## Planning Commission Study Session

SUBJECT: UP18-25 & DR18-163: GILBERT RECYCLING CENTER

UP18-25: Gilbert Recycling Center - a Conditional Use Permit for approximately 3.27 acres of real property located south of the southwest corner of Baseline Road and McQueen Road to allow a salvage yard in the General Industrial (GI) zoning district.

DR18-163: Gilbert Recycling Center - Site plan, landscape, grading and drainage, elevations, floor plans, lighting, colors and materials for approximately 3.27 acres, generally located south of the southwest corner of Baseline Road and McQueen Road and zoned General Industrial (GI).

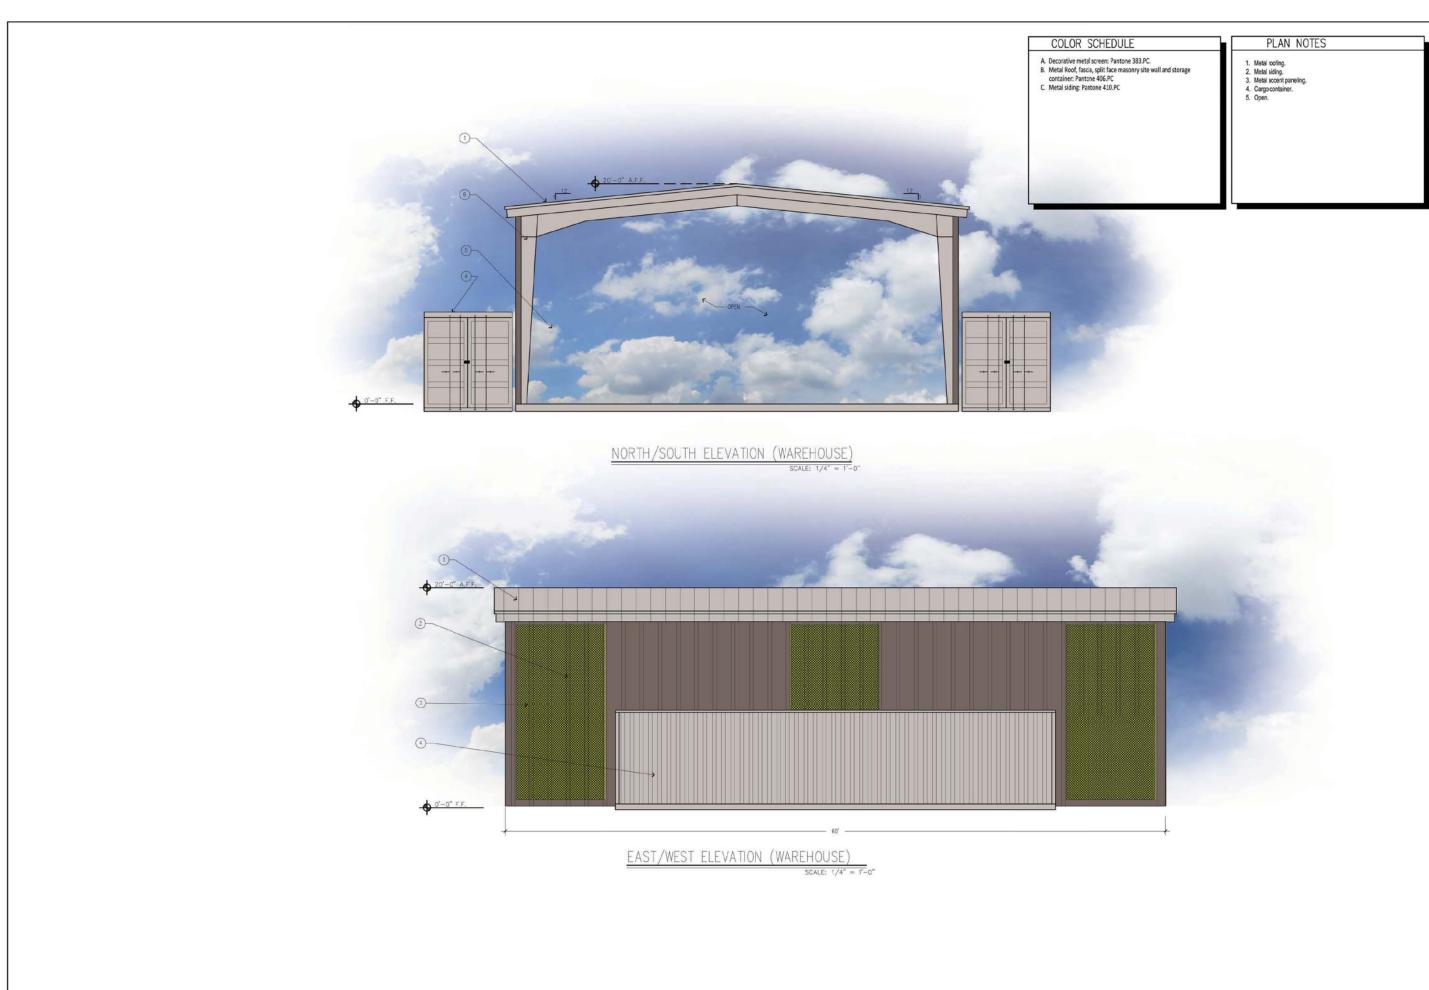
During first review, staff has expressed concern over the lack of vertical massing, horizontal massing, roofline variation, blank walls with no articulation, and the use of a shipping container on the west side of the office/warehouse building. Staff is suggesting that additional visual interest be provided on all elevations of both buildings to include additional texture, color, material changes, shadow lines, and other façade treatments. Concerning the shipping container on the west elevation of the office/warehouse building, Staff is requiring that the design be completely revised and that it be designed as integral part of the main structure matching the design of the overall structure.

- 1. General observations relating to overall site plan and site details
- 2. Lack of vertical articulation for buildings that are greater than 60' in length
- 3. Lack of horizontal massing on all sides but especially on the south and east sides
- 4. Roofline variation
- 5. Color variation
- 6. The use of a shipping container on the west elevation of the office/warehouse building
